Work Order ID 85892

Item Name: 205 Skidtube bent detail

DRAWING NO. D2580	TITLE 205 SKIDTUBE ASSEMBLY	REV. E	DART AEROSPACE LTD ENGINEERING ORDER		D.E.O. NO. D2580-E-1	SHEET NO. SHEET 1 OF 1	SCALE NTS
DRAWN <i>UP</i>	CHECKED <i>ASS</i>	MFG. APPR. <i>ER</i>	APPROVED <i>#</i>	DE APPR. <i>#</i>			
DATE 11.12.13	DATE 11.12.13	DATE 11.12.13	DATE 11.12.13	DATE 11.12.13

CHANGE ALL C'BORED WELDED CROSSBOLT SPACERS TO SWAGED SPACERS

SECTION B-B, F-F, I-I
NOT TO SCALE

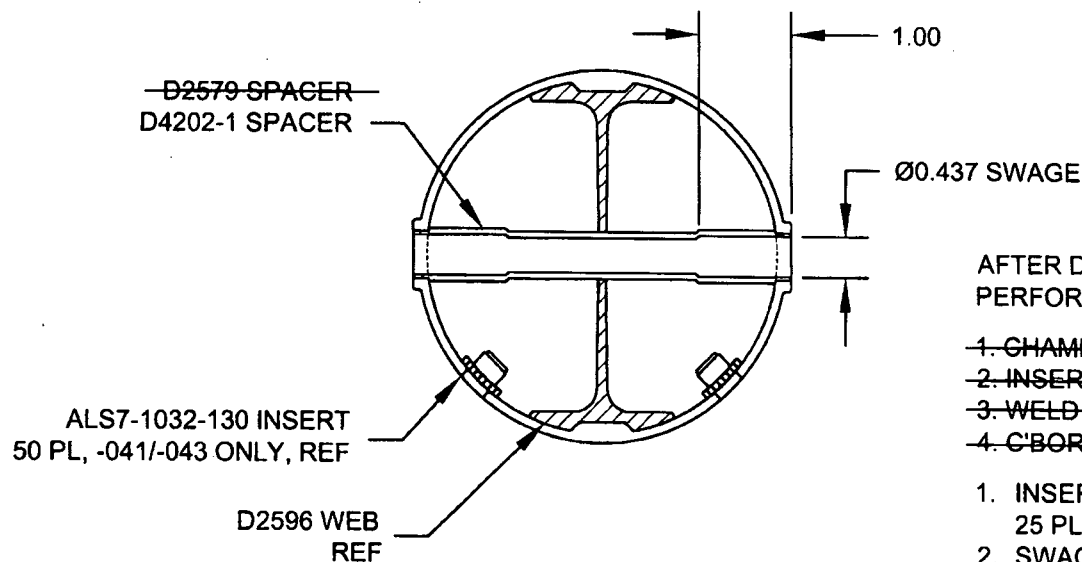
SECTION B-B, SECTION F-F, & SECTION I-I ARE AMENDED AS FOLLOWS FOR ALL HOLES THAT WERE ORIGINALLY C'BORED:

WELD 4X D2579 SPACERS PER DWG IN LOCATIONS MARKED "NO C'BORE".
REF SHEET 4 OF DWG.

- ~~1. CHAMFER HOLE 0.050 X 45°~~
- ~~2. INSERT D2579 SPACER (20 PLACES)~~
- ~~3. WELD INTO PLACE AND GRIND FLUSH~~
- ~~4. C'BORE D2579 SPACER TO Ø0.437 X 1.00 DEEP~~

1. INSERT D4202-1 SPACER, 20 PL (-041) OR 20 PL (-045) OR 25 PL (-047)
2. SWAGE TO Ø0.437 X 1.00 DEEP PER QSI 002
3. TRIM / GRIND FLUSH PER QSI 002
